**BROWNS FERRY NUCLEAR PLANT (BFN) - UNITS 1, 2, AND 3 -
TECHNICAL SPECIFICATIONS (TS) CHANGES TS-431 AND TS-418 -
EXTENDED POWER UPRATE (EPU) - RESPONSE TO ROUND 15 REQUEST
FOR ADDITIONAL INFORMATION (RAI) - APLA-38/40, SRXB-71, AND
SRXB-72 (TAC NOS. MD5262, MD5263 AND MD5264)**

**TENNESSEE VALLEY AUTHORITY
BROWNS FERRY NUCLEAR PLANT (BFN)
UNITS 1, 2, AND 3**

**TECHNICAL SPECIFICATIONS (TS) CHANGES TS-431 AND TS-418
EXTENDED POWER UPRATE (EPU)**

**RESPONSE TO ROUND 15 REQUEST FOR ADDITIONAL INFORMATION
APLA-38/40, SRXB-71, and SRXB-72**

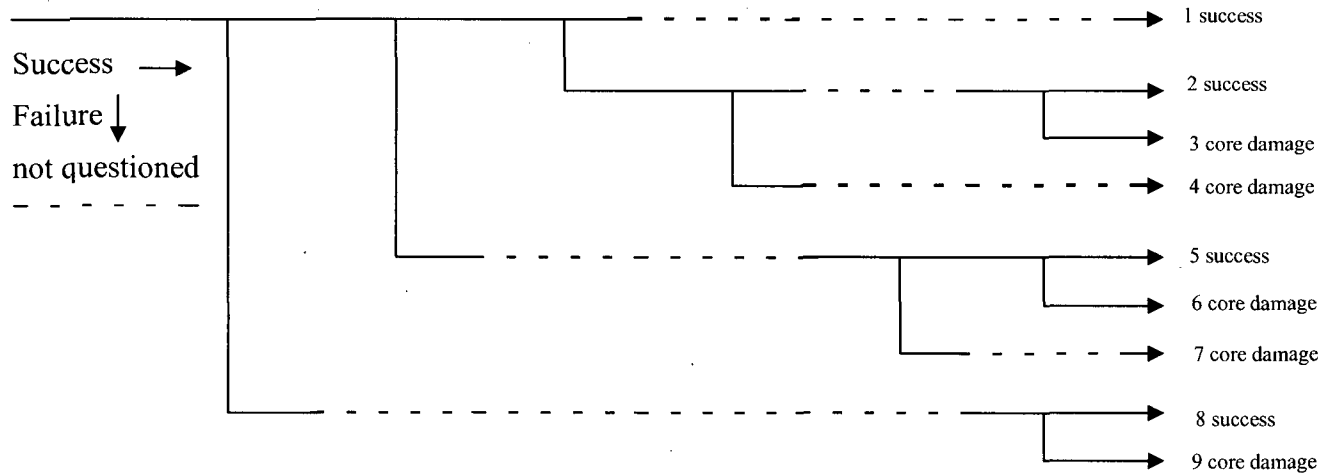
In the human reliability analysis, there are two operator actions related to depressurization following a failure of high pressure coolant injection (HPCI) and reactor core injection cooling (RCIC):

- HPRVD1, "Operator fails to depressurize given HPCI/RCIC hardware failed (OHPR=S)," apparently addresses HPCI/RCIC failure to due hardware failure. This event has a Fussell-Vesely importance of about 0.2 for Unit 2 and about 0.3 for Unit 3, and a risk achievement worth (RAW) of about 1560 for Unit 2 and about 864 for Unit 3.
- ORVD2, "Operator fails to depressurize given HPCI/RCIC hardware failed (OHPR=F)," apparently addresses HPCI/RCIC failure due to an operator control failure. This event has a Fussell-Vesely importance of about 0.13 for Unit 2 and about 0.07 for Unit 3, and a RAW of about 1.8 for Unit 2 and about 1.4 for Unit 3.

Address why these two events do not have similar RAW values. Briefly discuss how these events are incorporated into the probabilistic risk assessment logic structure, and how the RISKMAN software computes Fussell-Vesely important measures and RAWs.

A complete presentation of all factors impacting the risk importance of operator actions HPRVD1 and ORVD2 would be impractical to present here, however, the following simplified event tree below illustrates the fundamental relationships between high HPI, manual depressurization operator actions, and LPI.

Sequences 1, 2, and 5 above result in successful event mitigation, wherein HPI was successful, or successful manual depressurization together with successful LPI occurred. Sequences 3, 4, 6, and 7 result in core damage, because HPI failed (either short or long term) and successful manual depressurization together with successful LPI did not occur. Sequences 8 and 9, included here for completeness, do not involve HPI or manual depressurization, but rather depend on LPI success.

From inspection of the above event tree, it can be seen that ORVD2 is only questioned if short term HPI has failed, and since HPI reliability is good, ORVD2 plays no role in most sequences. HPRVD1 is questioned, however, if long term HPI fails, therefore HPRVD1 will be involved in a greater number of event sequences. Because HPRVD1 appears in a greater number of event sequences and because its actual failure probability is low, arbitrarily setting its failure rate to 100% for purposes of the RAW calculation will significantly impact the Core Damage Frequency (CDF) calculation, resulting in a large RAW value. Conversely, since ORVD2 appears in fewer sequences and its actual failure probability is high, the arbitrary setting of its failure rate to 100% will have a smaller impact on the CDF calculation resulting in a smaller RAW value.
